# Sumter City-County Planning Commission

April 27, 2011

## MSP-11-17 & HCPD-11-21, 325 W. Liberty St. – Cedars Medical Clinic (City)

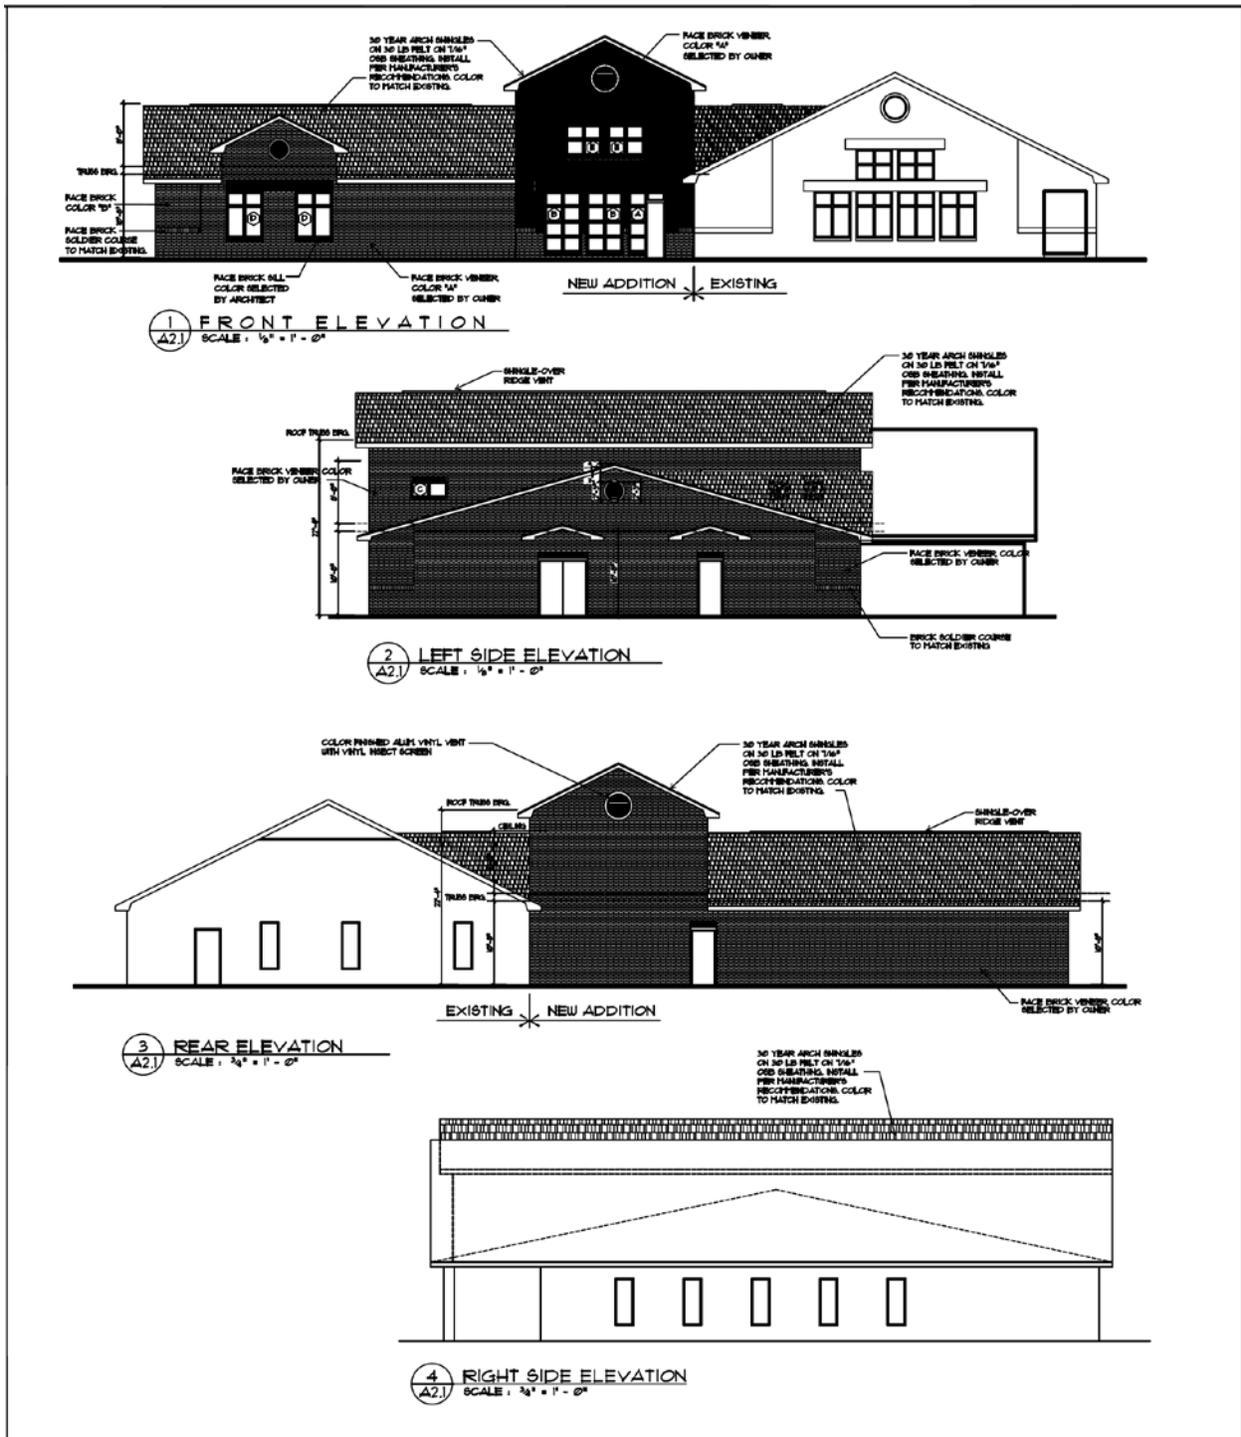
This is a proposed addition to an existing structure that will utilize the same brick materials as seen on the original structure as well as roof pitch and roofing materials.

Exterior building materials will be similar in color and style as the existing portion of the building shown above. The elevations on the following page depict the proposed structure. The building addition is creating a new entrance on the W. Liberty St. façade. Currently the main entrance to the structure is on the east side of the building facing the interior property line.

As shown in the rendering on the following page, the proposed building addition is compatible in terms of materials, massing, roof pitch and scale as that of the existing structure.
